Comments received on withdrawn Application

RE: EXPANSION OF LIQUID OXYGEN AND DIESEL STORAGE AT THE AIR PRODUCTS FACILITY LOCATED WITHIN THE COEGA SPECIAL ECONOMIC ZONE, PORT ELIZABETH, EASTERN CAPE PROVINCE

PROVINCIAL REGISTRATION NUMBER: Ecm1/C/LN1/M/40-2019

### **BASIC SITE ASSESSMENT REPORT FOR THE EXPANSION OF LIQUID OXYGEN AND DIESEL STORAGE AT THE AIR PRODUCTS FACILITY LOCATED WITHIN THE COEGA SPECIAL ECONOMIC ZONE, EASTERN CAPE.**

Figure 4. Location of Diesel Tanks. Diesel tank locations are highlighted in green. The boundary wall is located at the top of the image which borders Dynamic Commodities.

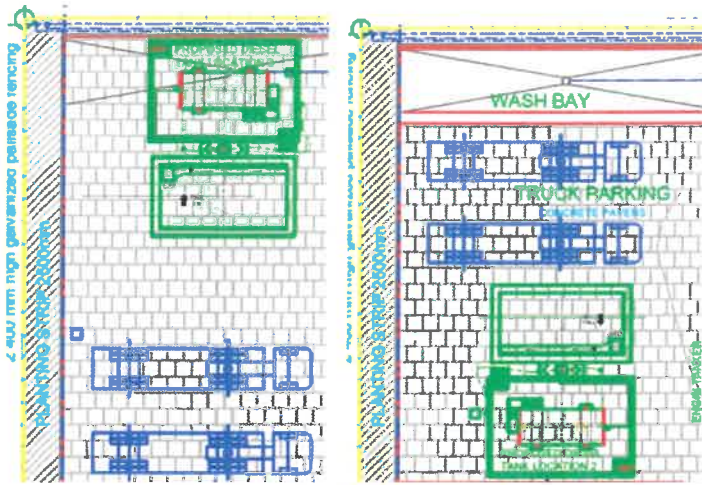
These factors would have to be considered from a food safety perspective as these emissions are harmful to food products. Additionally, under the South African National Standard 10131:2004 subsection 4.2.2 "Location of above-ground tankage" [2] it states that, cognizance shall be taken of population densities around the premises and good housekeeping such as the removal of flammable materials such as rubbish, dry vegetables and oil-soaked soil. Additionally, it states under subsection 4.3.1 "General tankage layout – minimum safety distances" that safety distance is based upon the class of liquid. Diesel is classified as a class II liquid, therefore the minimum safety distance from a boundary of an adjacent property is 3m. The proposed location of the diesel tanks (Fig 4) lies close to our boundary fence. Furthermore, since we are a food manufacturing facility specialising in fruits and vegetables such dried matter can occasionally be found along our boundary fence. Additionally, the area directly adjacent to the proposed location houses our old equipment and storage bins. This old factory equipment could contain reflective material possibly able to generate heat while the bins contain rubbish, which may be ignited. Fires started by reflective metals or glass have had devastating effects and their ability to start fires has been studied for many years [3].

From an operational healthy and safety aspect, some of our maintenance and raw material personnel frequently operate in this area. As stated in the Major Hazard Installation report, the tank was not to be placed near the guard house on the initiator's premises due to the presence of the building and personnel. We would like if this courtesy were extended to encompass our own personnel who work in the area. The Major Hazard Installation report also reflects that wind is likely to blow vapours in the direction of the bulk cryogenic storage facility, however, this appears to be unlikely. Data gathered from two differing sources (Fig 5 [4] and 6 [5]) indicate that, for most of the year, wind direction maintains a South to South West consistency. Our storage facility and collection point lie at South-West: 202° whilst our location for storage of old equipment lies at South: 207°.
